# PARTS & SERVICE NEWS

REF NO.	AT02013
DATE	Feb. 5, 2002

**SUBJECT:** INTRODUCTION OF DUST-PROOF COVER OF TRANSMISSION SUCTION STRAINER ON WA1200-3

**PURPOSE:** To introduce a newly developed dust cover for the suction strainer section of the transmission assembly on WA1200-3 wheel loaders

2. Shape and dimensions of the dust cover (Part No.: 42C-15-13170)

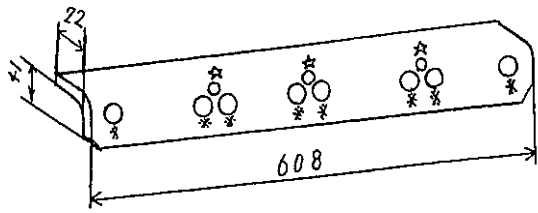
Plate thickness: 4.5 mm  
 Bolt holes: (At 8 places marked ※)  
 Through holes: (At 3 places marked ☆)  
 (To drain water)  
 Weight: 1.3 kg

Position to install the dust cover

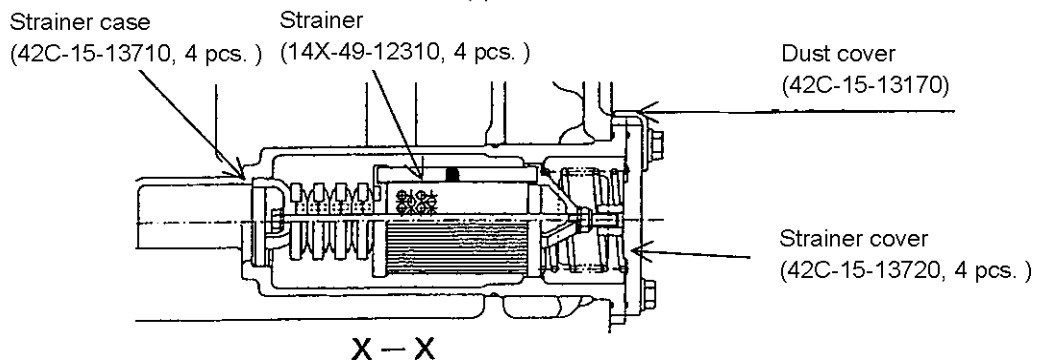
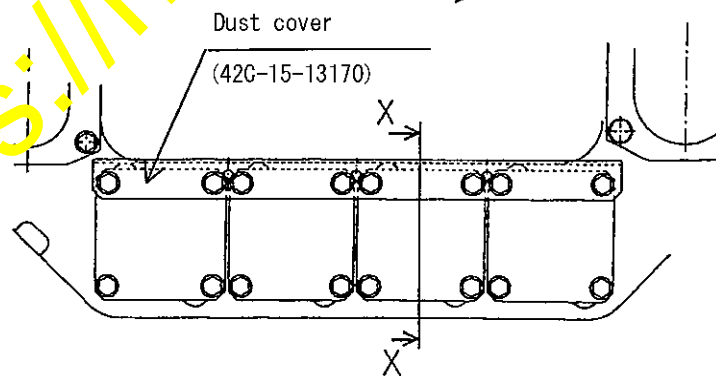
Also, for installation of the newly developed dust cover, the length of the bolts has been changed.

## ① Precautions when making the installation work

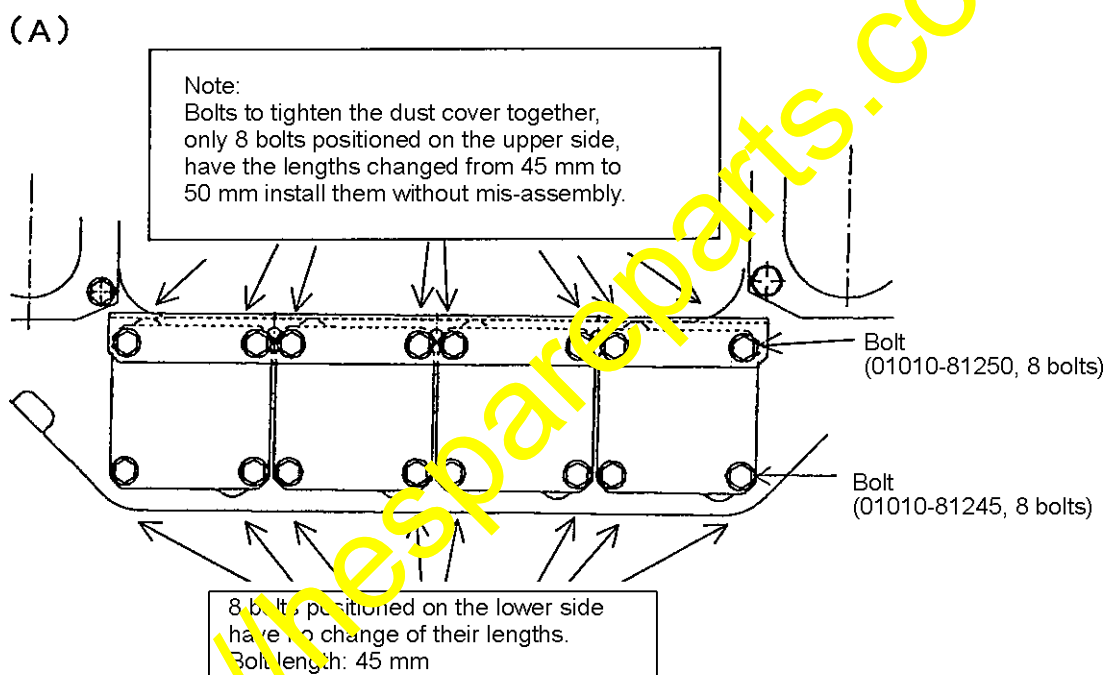
- (1) When installing the dust cover, if mud and sand have already accumulated, clean to remove the mud and sand completely.
- (2) Remove the 8 bolts ( $\ell = 45$  mm) being positioned on the upper side and fasten the dust cover together with the strainer covers using the new bolts ( $\ell = 50$  mm) which are 5 mm longer than the current bolts. (Refer to the Drawing (A) below.)
- (3) In order to eliminate the opening as much as possible, make fine adjustment of the positioning of the dust cover so that the dust cover may come in sufficient contact with the convex portion of the strainer case (at 4 places).

Contact bolts with 4 convex portions of the strainer case.
